**RE: Response to Disapproval
Investigation Report Solid Waste Management Units (SWMU)
No. 4 Old Burn Pit and No. 5 Landfill Areas
Marathon Petroleum Company LP, Gallup Refinery
(dba Western Refining Southwest LLC)
EPA ID# NMD000333211
HWB-WRG-17-006**

Attachment A: Response to Comments

New Mexico Environment Department to Marathon Petroleum Company Comment Letter “Response to Disapproval, SWMU No. 4 Old Burn Pit and No. 5 Landfill Areas Investigation Report” (March 15, 2021)

INVESTIGATION REPORT
Solid Waste Management Units (SWMU)
No. 4 Old Burn Pit and No. 5 Landfill Areas

FIGURE 9
CROSS SECTION A-A'
GALLUP REFINERY

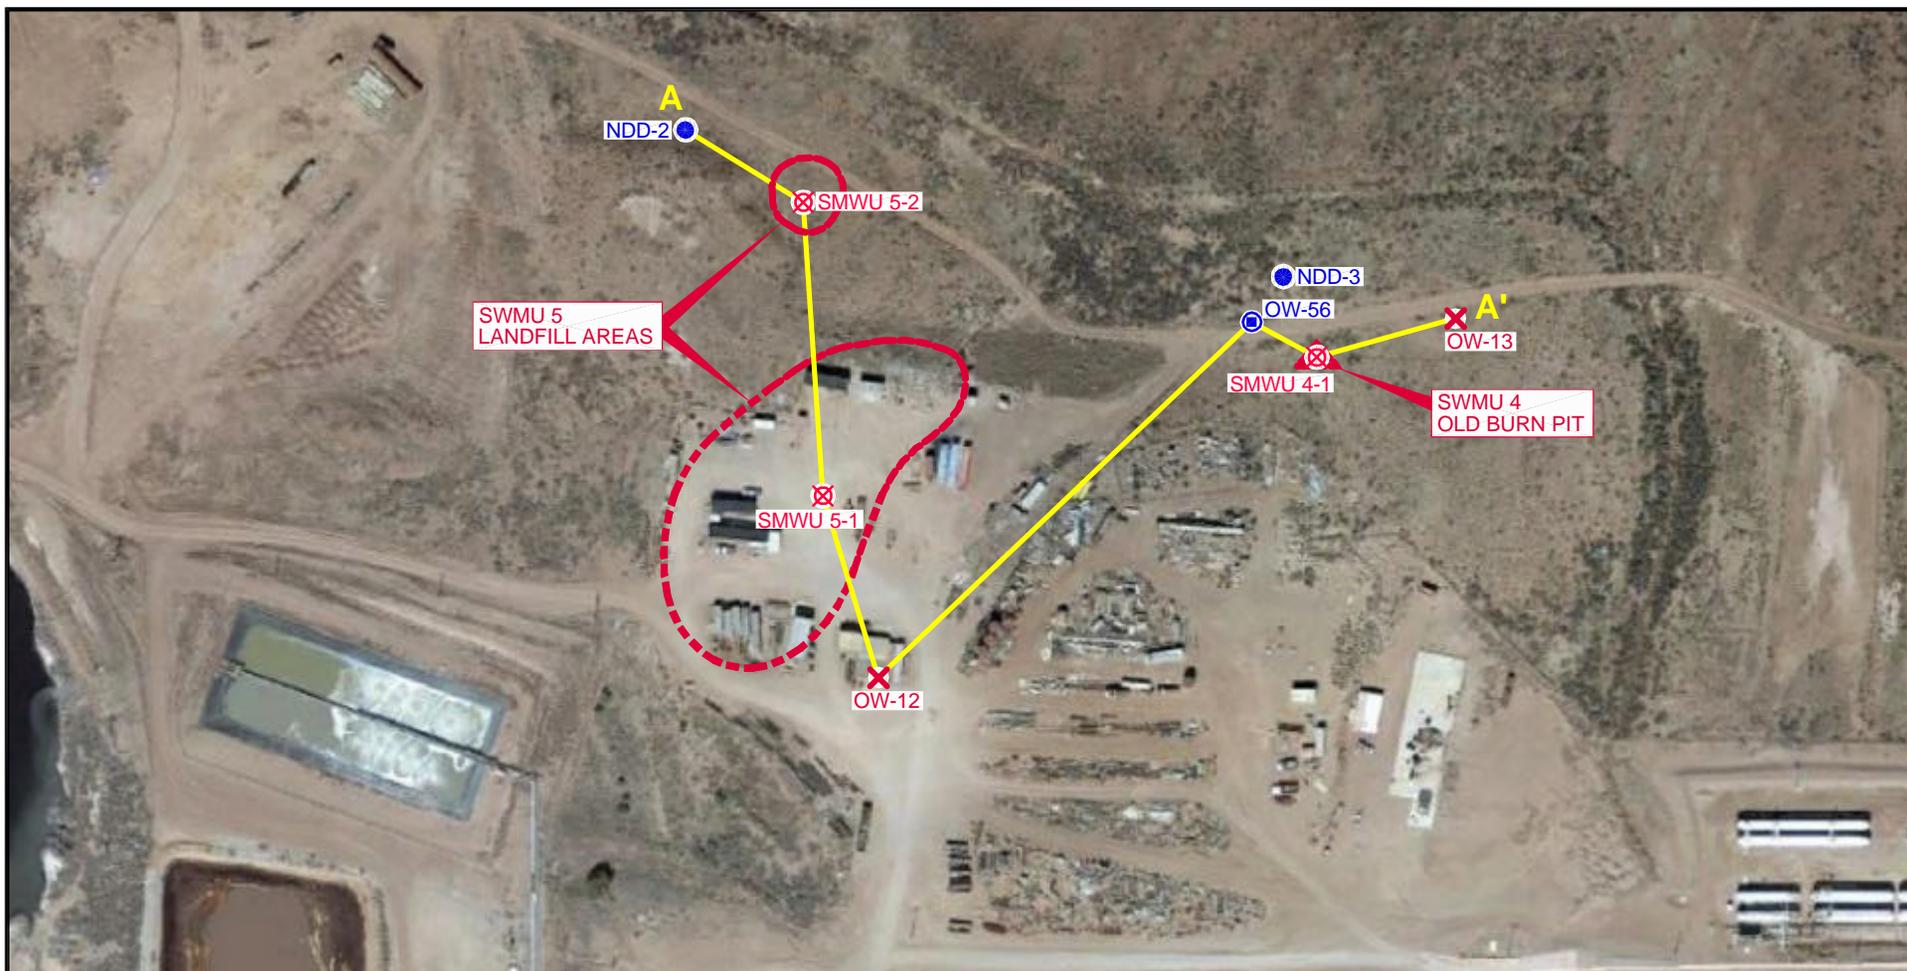
<p>Comment 3:</p>	<p>Response 3:</p>
<p>Figure 9 (Cross Section A-A’) includes data from soil boring NDD-2, boring SMWU 5-2, boring SWMU 5-1, well OW-56, and boring SWMU 4-1. There are several issues regarding the cross-section and conclusions. The boring logs for several of the borings and well OW-56 were not included with the Report. However, the Permittee’s <i>Response to Disapproval No Further Action Report and Supplemental Information</i> (Response), dated June 15, 2015, includes information regarding boring NDD-2 which was drilled as part of the investigation for the North Drainage Ditch. The boring log indicated that claystone was encountered at approximately 4 feet bgs. Additionally, a soil boring named NDD-3 was drilled a short</p>	<p>The boring logs for NDD-2, NDD-3, and OW-56 have been included in Appendix D of the revised Investigation Report. A cross section revised to include the borings requested by NMED has also been included as Figure 9 in the revised Investigation Report. The approximate locations of the SWMU 4 and SWMU 5 are shown on Figure 9. The depth of SWMU 4 was approximately 10 to 12 ft bgs. The depths of SWMU 5 landfills are unknown.</p>

<p>distance north of the Burn Pit and east of boring NDD-2 as well. The description of NDD-3 in the Response states:</p> <p>“[i]n this boring, claystone was encountered at 12 feet below the land surface. Saturated clayey, gravelly, sand was observed overlying (10’-12’) the claystone and a temporary well completion was installed to facilitate collection of a groundwater sample. The analysis of the water sample indicates the presence of low concentrations of gasoline and diesel range organics, benzene, 1,2-dichloroethane, methyl tert butyl ether, isopropylbenzene, and sec-butylbenzene. Methyl tert butyl ether and 1,2-dichloroethane were detected at concentrations above screening levels.”</p> <p>Saturation was observed at approximately 12 feet below ground level in a clayey gravelly sand directly above the claystone which correlates to historic boring logs for the Landfill Areas that indicate wet/water/water bearing zones between 6.5 and 17 feet below the ground surface. Historic boring logs for the Burn Pit indicate that no saturated interval was encountered during investigation. The boring logs demonstrate that intermittent groundwater within the Chinle/Alluvium interface is present. The Report did not provide adequate information: provide the boring logs for NDD-2, NDD-3, and OW-56 in the revised Report. Provide a cross-section that includes more information and borings SWMU 4-1, boring NDD-3, well OW-56, boring SWMU 5-2, and boring NDD-2. Evaluate the appropriateness of also including boring SWMU 5-1. Additionally, please mark the locations and depths of the landfills and burn pit on the cross-section.</p>

4. Figure 2 has been revised to show the locations of OW-12 and OW-13 and Figure 9 presents a revised cross section; these figures are provided in the revised Investigation Report. The boring log for OW-56 has been included in Appendix D of the revised Investigation Report. In response to NMED’s comment regarding site-specific data, Section 4.2.2 (Hydrogeology) page 4-4 has been revised to state:

FIGURE 2
SWMUs No. 4 & No. 5 LOCATION MAP
GALLUP REFINERY

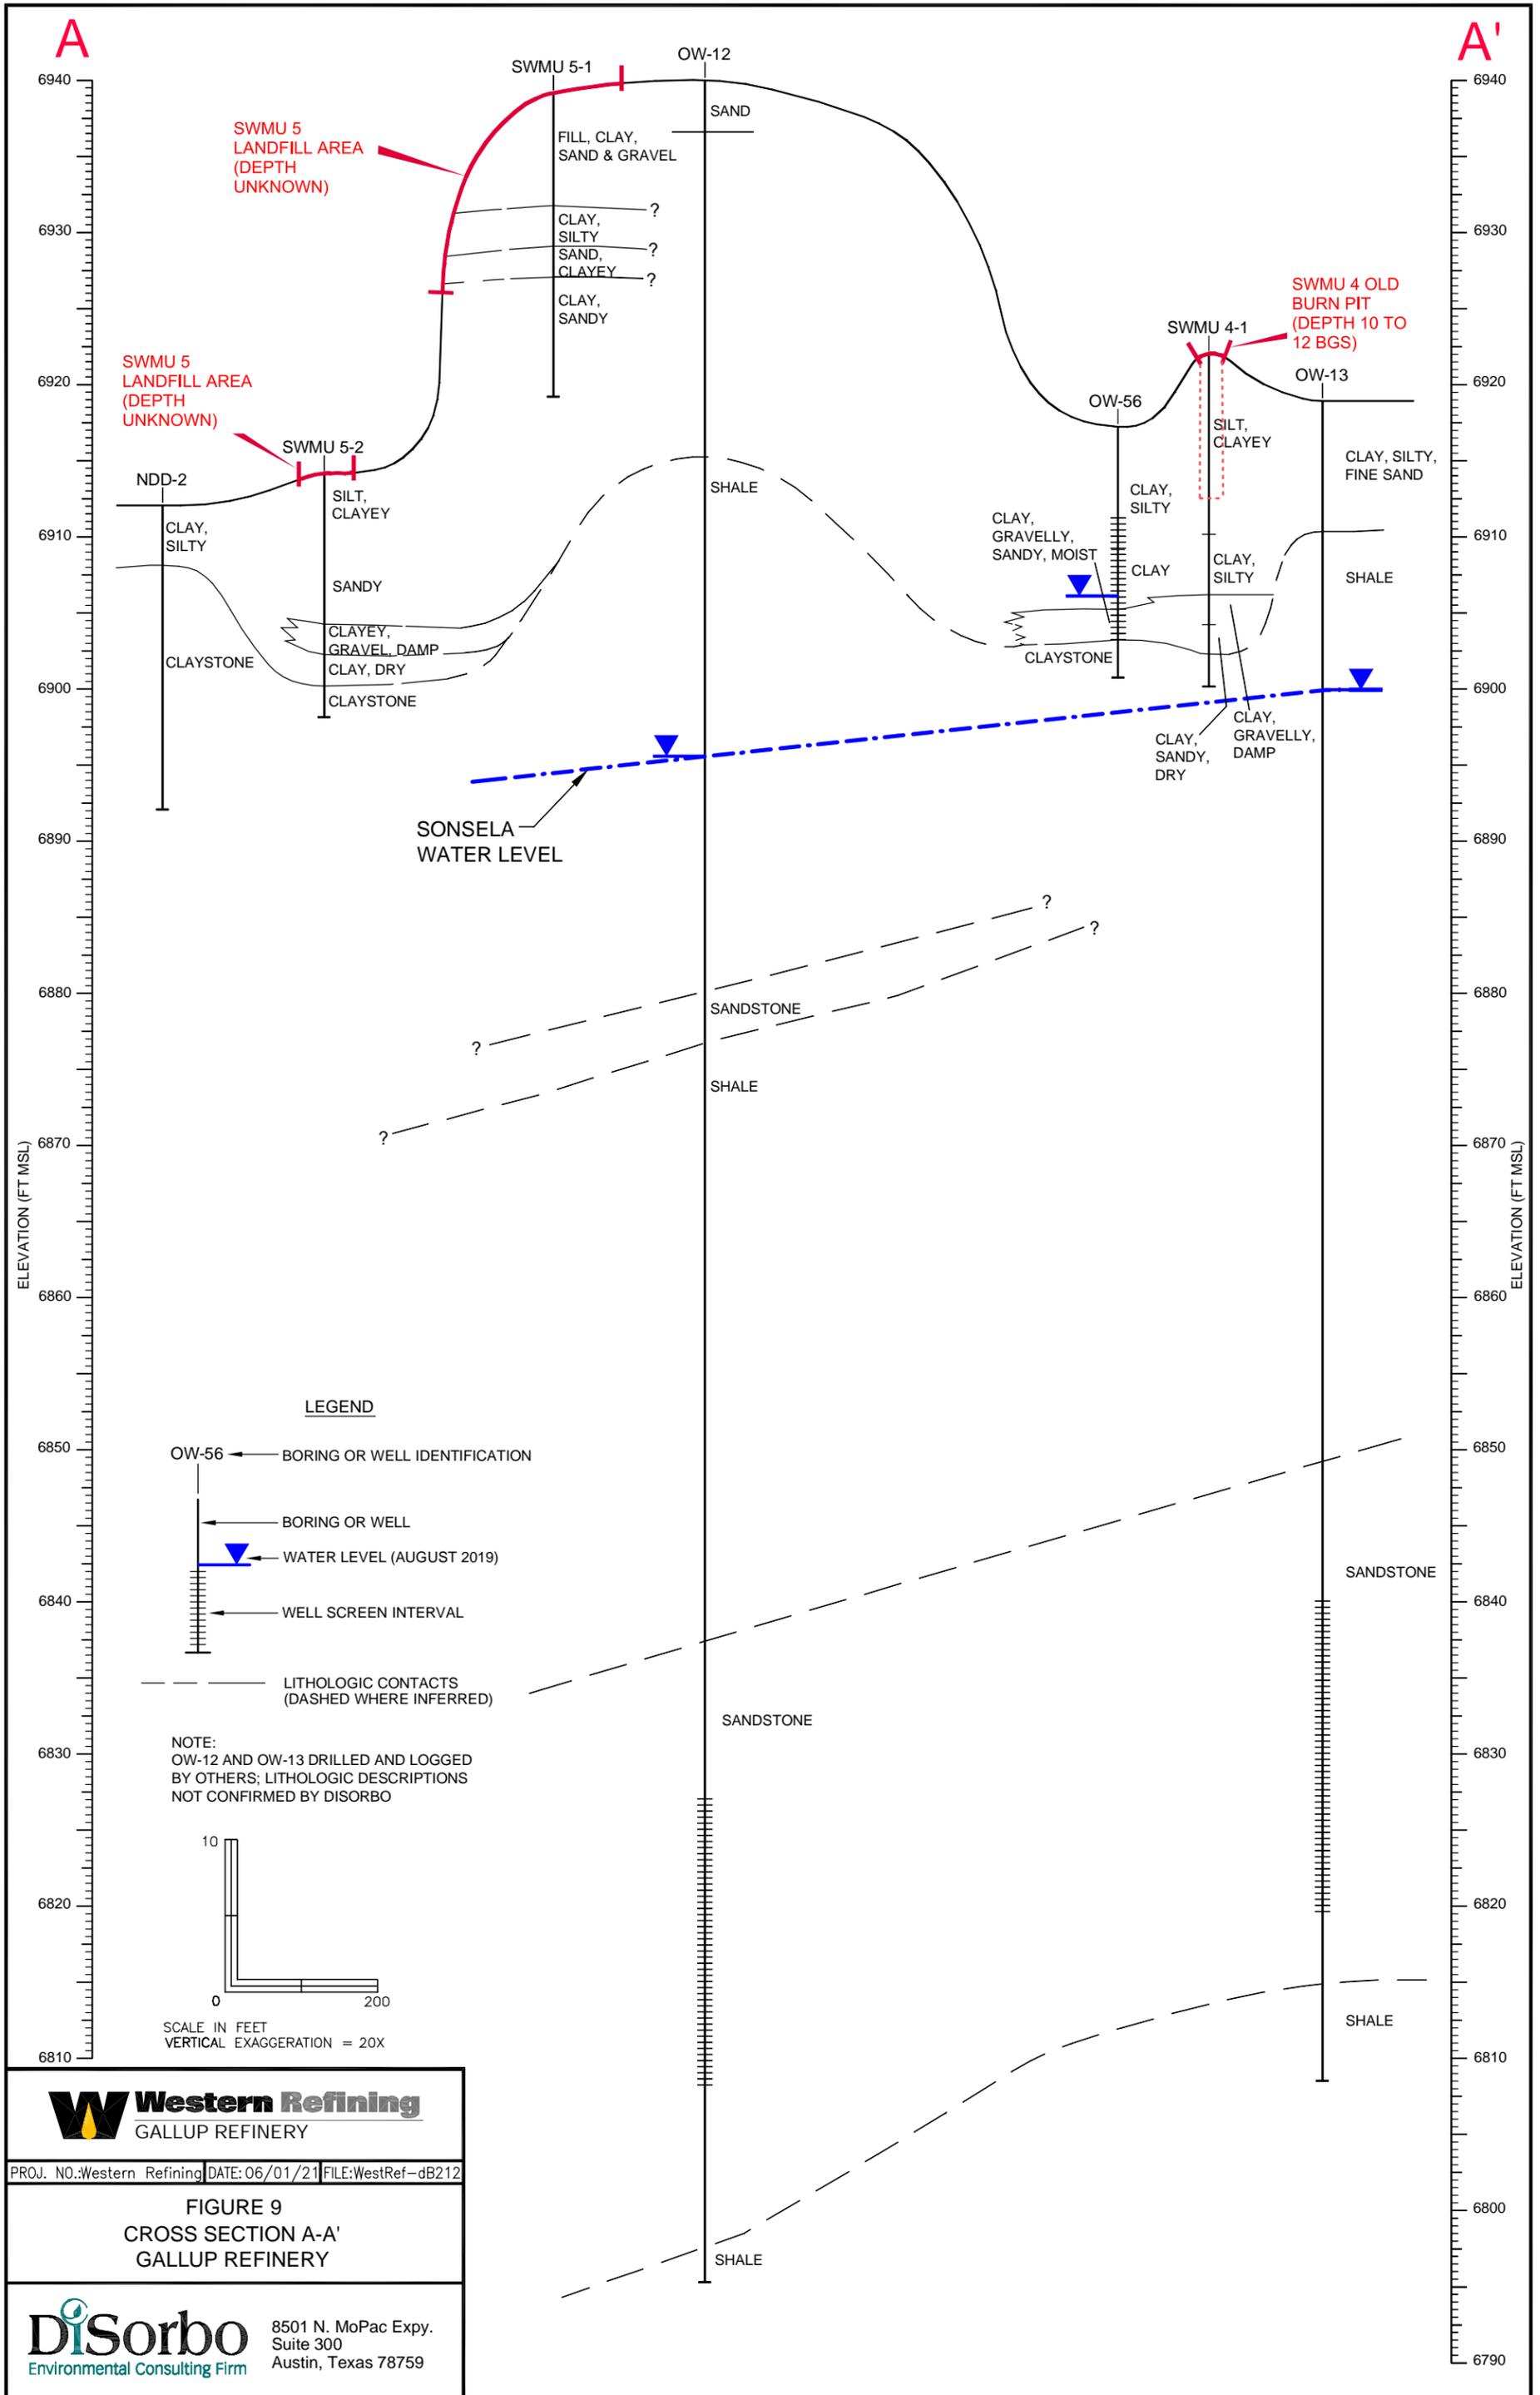
2. Figure 2 (SWMUs No. 4 & No. 5 Location Map) depicts the locations of the SWMUs, soil borings, a monitoring well (OW-56), a temporary monitoring well (NDD-2), and a cross-section A-A'. The Permittee did not include a boring log or well construction diagram for monitoring well OW-56 in the Report. However, Figure 9 (Cross Section A-A') includes a legend depicting monitoring well OW-56 that shows a general well diagram and lithologic information is included within the cross-section. The cross-section does not indicate saturation, but the lithologic information included for well OW-56 describes an interval from 6906 to 6904 ft msl as “clay, gravelly, sandy, moist”. Additionally, “damp” intervals were encountered in borings SWMU 5-2 and boring SWMU 4-1 at similar intervals to the moist interval in well OW-56. The Permittee must discuss site-specific groundwater in Section 4.2 (Subsurface Conditions) and discuss the presence of intermittent saturation. As the Permittee is aware, tight clays often prevent timely recharge within borings and wells, so the presence of groundwater may not be immediately observed.

3. Other than well OW-56 and NDD-2, the closest monitoring wells are OW-12 to the south and OW-13 to the east (not depicted on the figures in the Report). These wells monitor the Sonsela aquifer with depths to water at 47.23 ft bgs and approximately 21.5 ft bgs, respectively. There may be water present within the Chinle/Alluvium interface, as recorded in other areas of the refinery, but the boring logs for OW-12 and OW-13 are not detailed enough to determine if saturated intervals were encountered in these wells. Also, because of the difference in reporting the elevation of the subsurface data (ft msl in the Report versus feet bgs on the OW-12 and OW-13 well logs), it is difficult to determine whether the saturated intervals in the OW-12 and OW-13 wells can be correlated to the moist and damp intervals in the monitoring well and borings installed as part of the investigation.
